RE: IESI – Bethlehem Landfill
Response to EAP Letter Dated 9/27/16
Our file: b/1162.3/2016/EAP/RL92716

We are in receipt of your September 27, 2016 2nd EAP review letter and are providing responses as follows. We have included the DEP comments in conventional font, with our responses in **bold text**.

Southeastern Realignment - Cap Removal & Waste Relocation Plan and Procedures

CADD FILE: 1162-3SERV14-07 R1.dwg

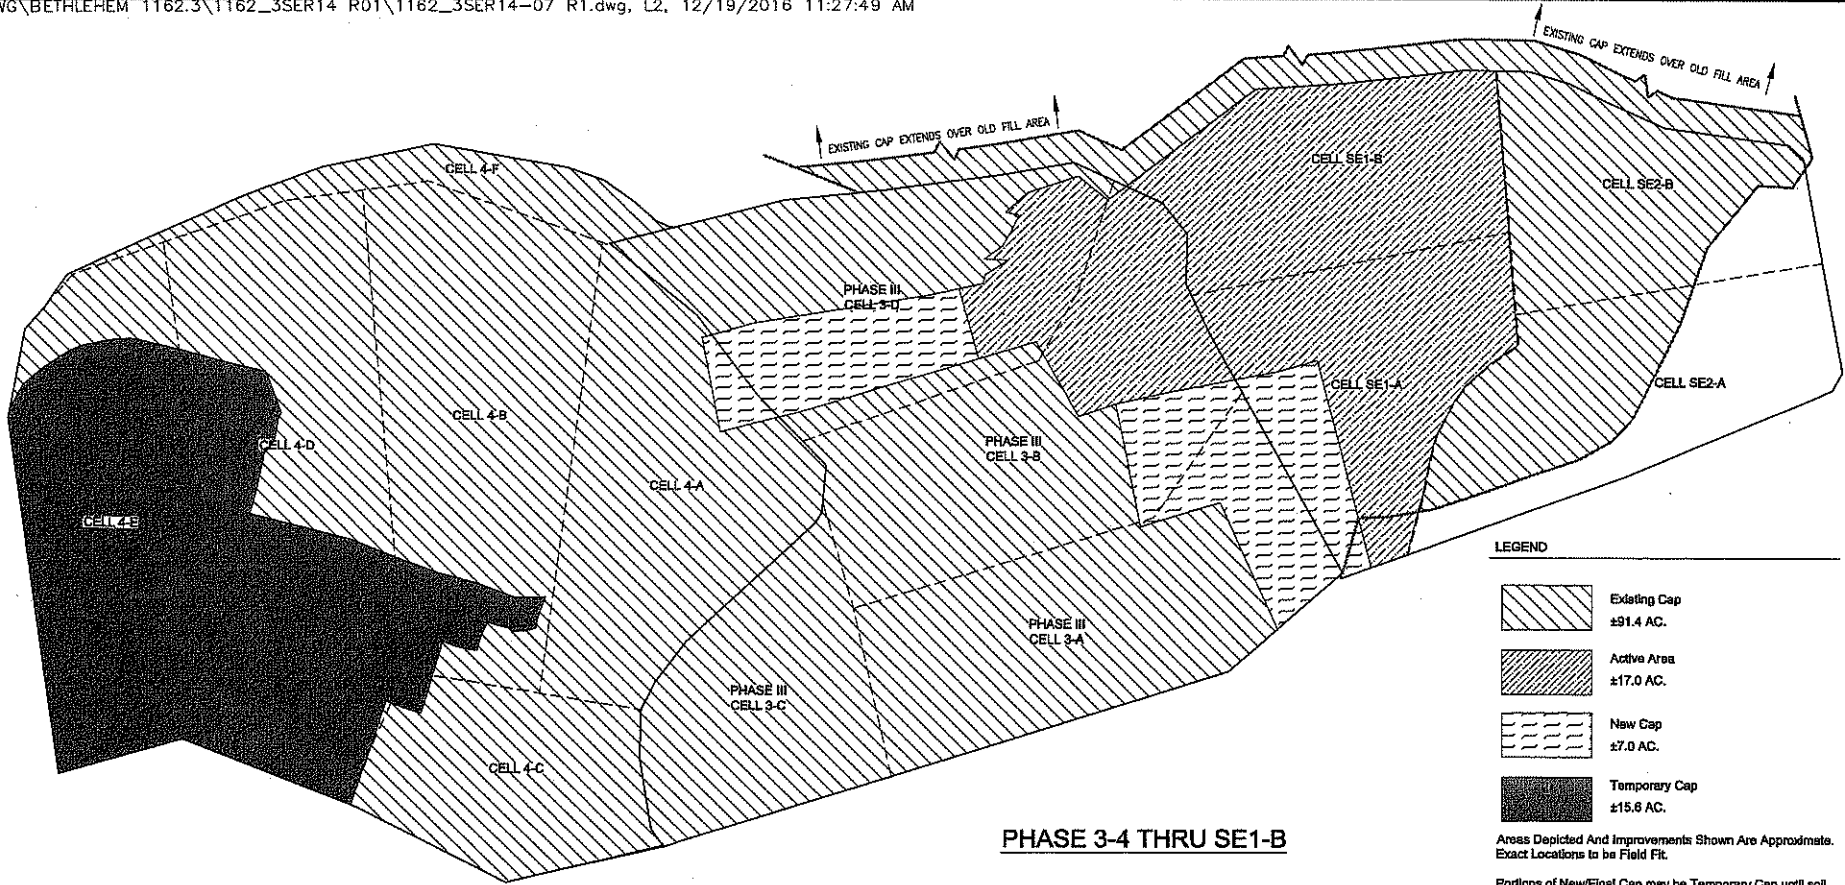
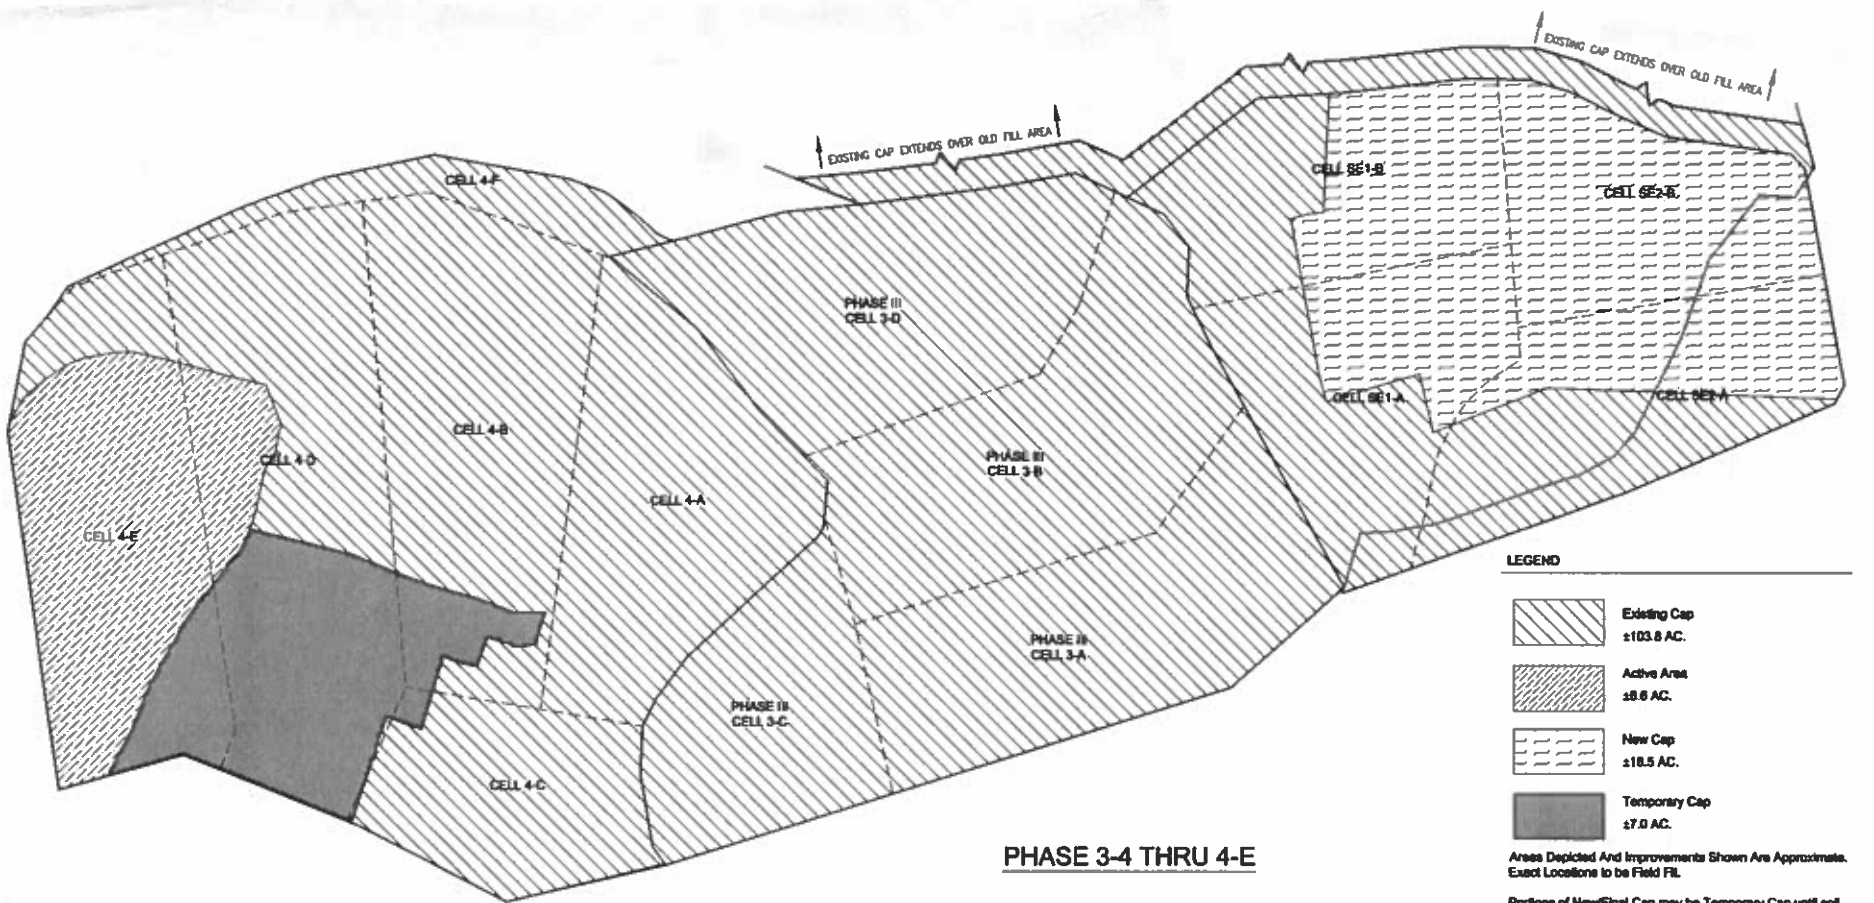
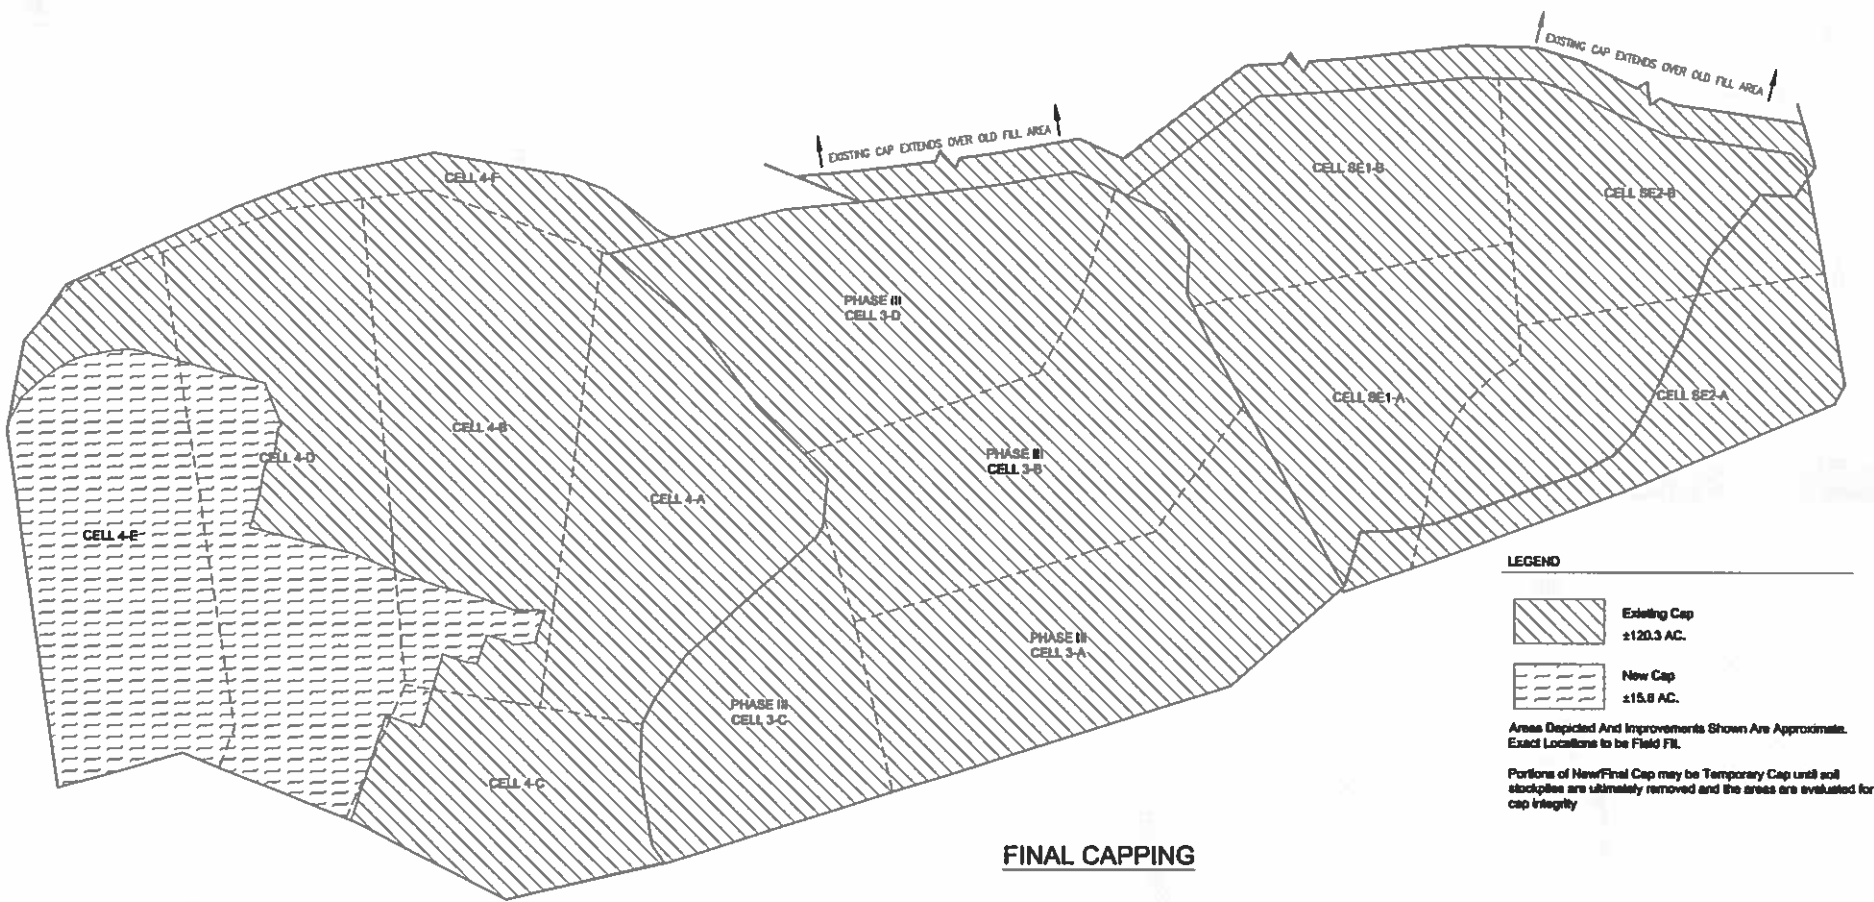
The application should be revised to include more detailed information on the sequencing of the cap removal, gas system removal and construction within Cells SE1-A, SE1-B, SE2-A and SE2-B.

DEP review: The Southeastern Realignment application should be a standalone document and should not reference details included in past applications. In addition, the July 17, 2013 permit modification is only for removal of cap in a ½ acre area. This proposal is for removal of 26 acres. IESI should provide detailed information as to the sequencing of cap removal, gas system removal and construction within Cells CE1-A, SE1-B, SE2-A, AND SE2-B.

therewith as a part of the approved Land Development Permit. Additionally, LF-26 to LF-28 of the Landfill design plans, included here as Attachment 2, show the sequencing of areas where active filling will take place as the various phases of construction/operation evolve. Where there is existing cap within those areas, it will be removed per the Cap Removal Plan (Attachment 1). Per that Plan the ..."area will be limited to that which can be managed within a day or two."

Attachment 5

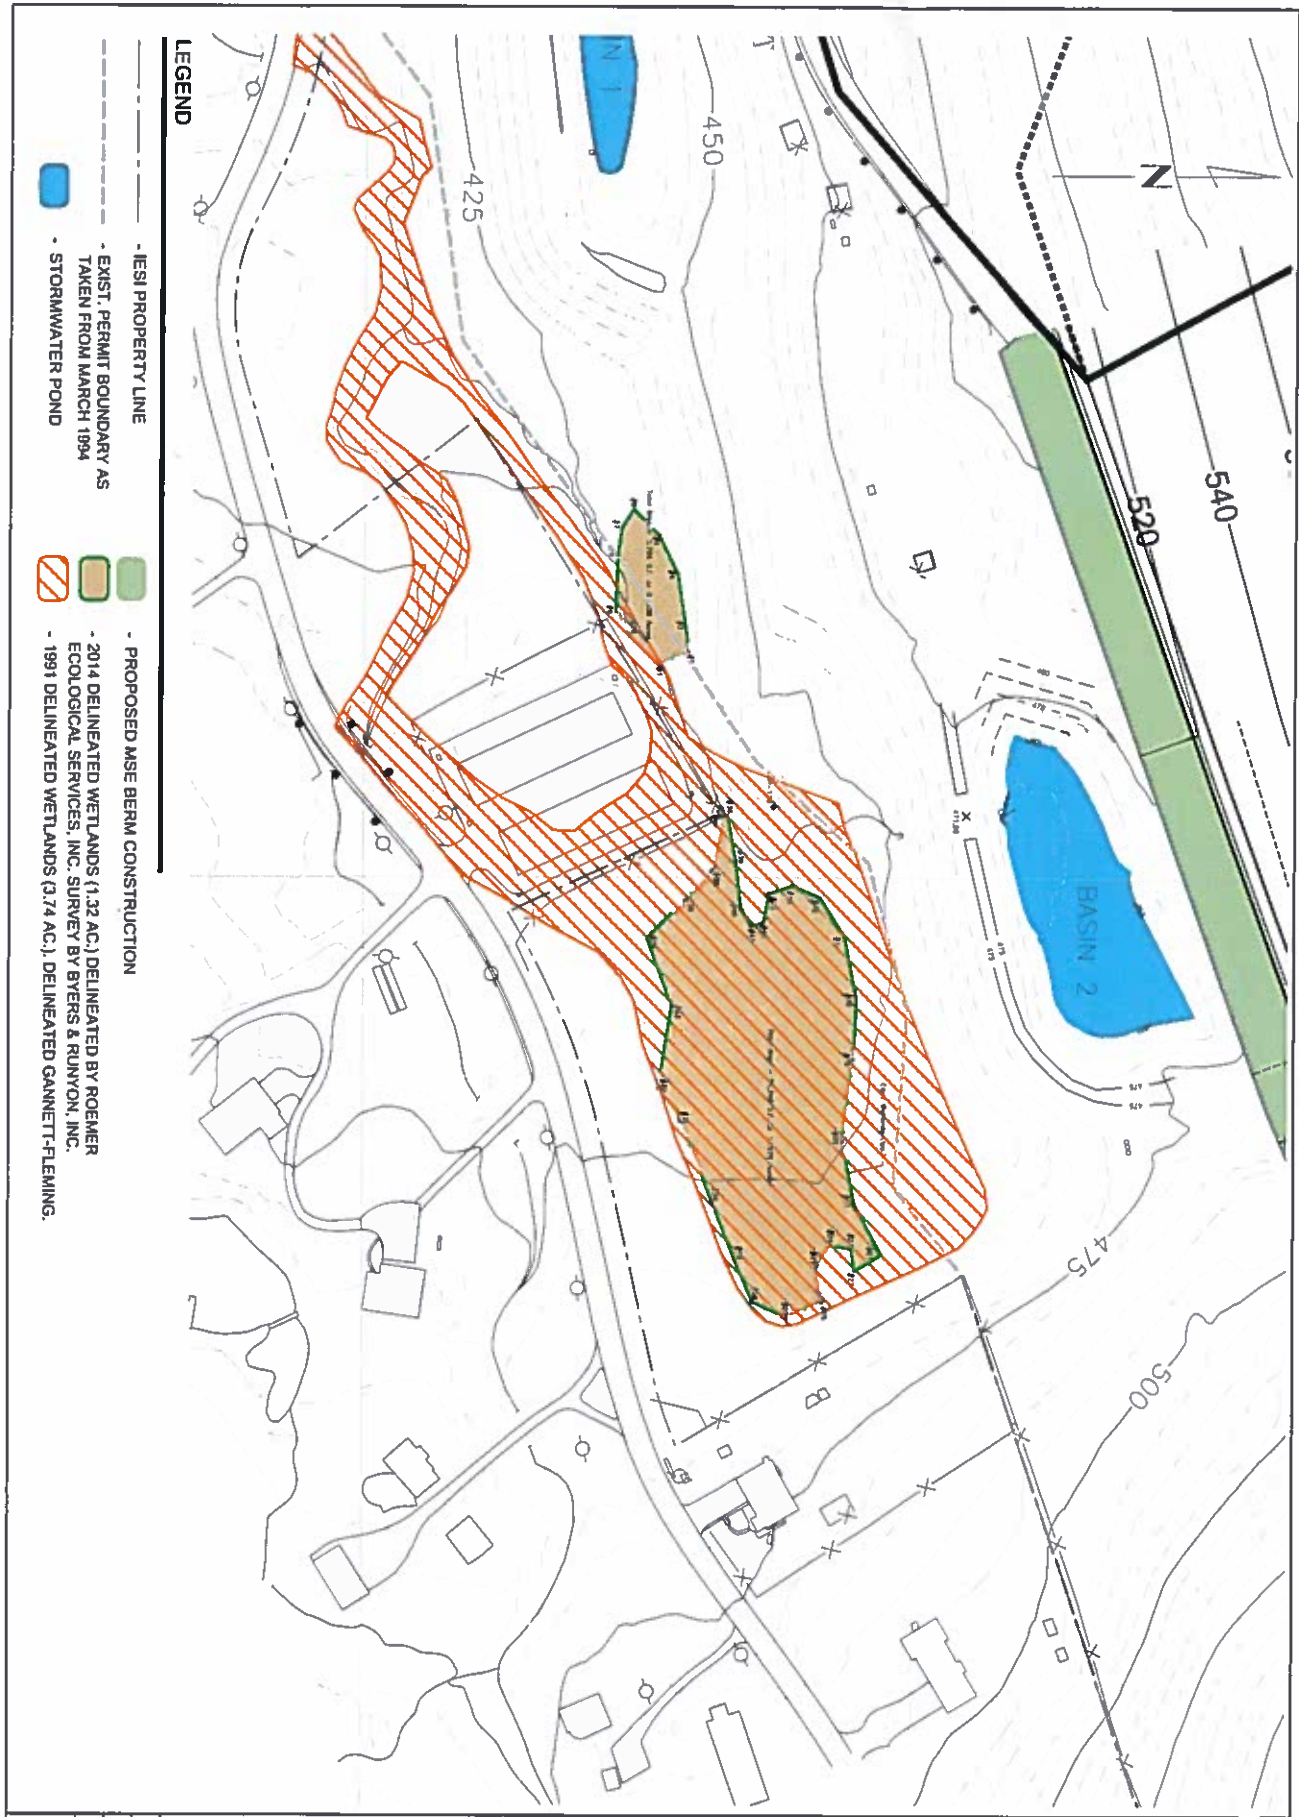
DEP’s Waterways and Wetlands program has reviewed IESI’s response to the first EA review letter and determined IESI has not fully addressed the reduction in size of the wetlands. IESI’s response states, “As discussed in the letter from Roemer Ecological Services, the reduced size of the wetlands area is believed to relate entirely to the intervening installation of a public storage structure and the grading work done on that parcel and to the stream channel associated therewith.” This response appears to identify the development of the public storage structures as the cause for the disparity in the two delineations; however, the response lacks detail into the areal impact and reduction of wetland resources. IESI needs to provide a comparison of the two delineations (in plan view) to show how the wetlands may be impacted by the public storage structures or other factors. Furthermore, any activities from 1991 through 2014 that have impacted the wetlands which may have contributed to a loss of the wetlands should also be further detailed in this analysis

The 1991 and 2014 delineated wetlands are shown on Attachment 5. Note that the 2014 area of wetlands is reduced to 1.32 acres as compared to the 1991 wetland of 3.74 acres. Looking at Figure 5, it is clear that a corner of the more westerly of the 2 storage buildings on the commercial lot along Applebutter Road (developed and owned by others) immediately southwest of Basin 2 is entirely within the 1991 delineated wetlands, as is a majority of the more easterly one. Additionally, significant areas of the associated driveways and site grading on that lot are within said former wetland area. It is also apparent that the stream channel was directly affected (including rechanneling) by the commercial lot development.
